2002 Toyota Camry LE

M.I.L. "ON" DTC P0420

TECHNICAL SERVICE BULLETIN

Reference Number(s): EG024-04, Date of Issue: April 03, 2007; July 27, 2004; July 07, 2004

Fig. 2: Identifying ECU-IG Fuse Location
 Courtesy of TOYOTA MOTOR SALES, U.S.A., INC.

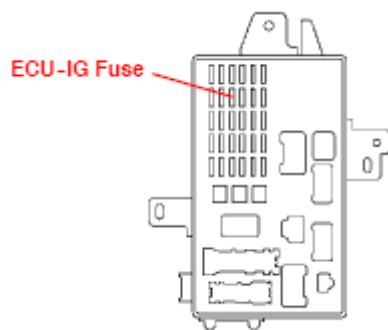
- **April 3, 2007:** A new step 3 and Figure 2 have been added to the ECM Reprogram Procedure (regarding removal of the 10A ECU-IG fuse). Previous Figure 2 is now Figure 3.
- **July 27, 2004:** The OP Code in the Warranty Information table has been changed from Combo A to Combo B.
- **July 7, 2004:** The Parts Information, Warranty Information, Applicable Vehicles and the Note in the Introduction have been changed.

3. Remove the 10A ECU-IG fuse from the instrument panel Junction Block (refer to **Fig. 2** for location). This action prevents possible activation of the ABS relay, resulting in ECM Reprogramming failure.

NOTE: ECU damage may occur if the 10A fuse is NOT removed.
